PHILCO RADIO-PHONOGRAPH MODELS 51-1730 and 51-1730(L)

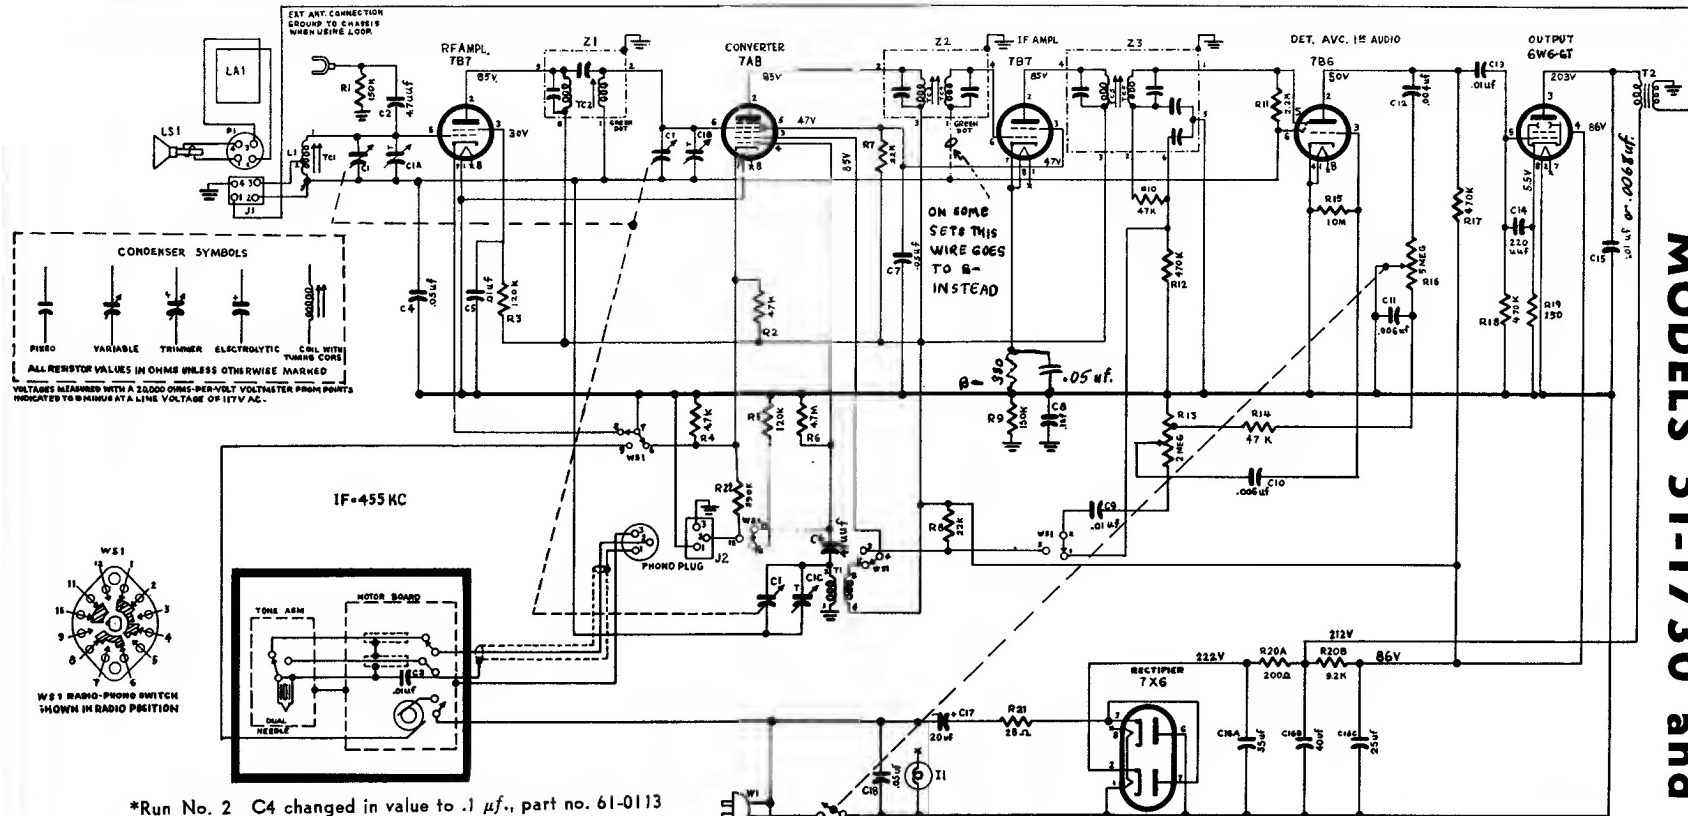
*Run No. 2 C4 changed in value to .1 μ f., part no. 61-0113
C9 changed in value to .006 μ f., part no. 45-3500-7
